# Field Modification Note

**075063700**

## **8916 AUTO-TRACKING DELAY**

ASSEMBLY NUMBER 671-4853-01

Figure 1. Jumper Modification

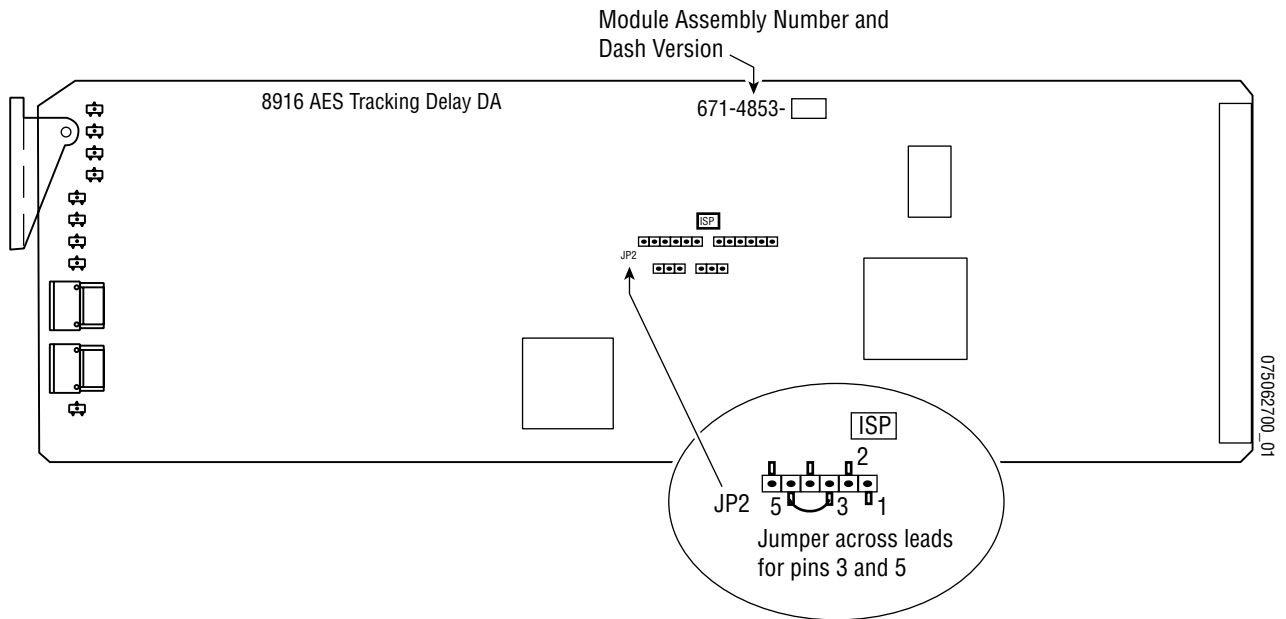
This field modification corrects a problem with the Philips microprocessor by fixing the programming voltage during remote download. This prevents the potential corruption of data that could occur during transition of the programming voltage. It requires soldering a jumper wire to the ISP connector on the module. The module will then allow successful remote downloading of software.

1. Locate any 8916 module which may need to be modified and remove it from the frame. The module can be removed with the frame powered up.
2. Confirm that the module is a -01 version. The assembly number is silkscreened on the component side of the circuit board as illustrated in Figure 1 on page 2. The dash version is written in the white box to the right of the assembly number.
3. Locate the ISP jumper, JP2, shown in Figure 1.
4. Solder a piece of insulated 30 AWG wire from the leads between pin 3 and pin 5 as shown.
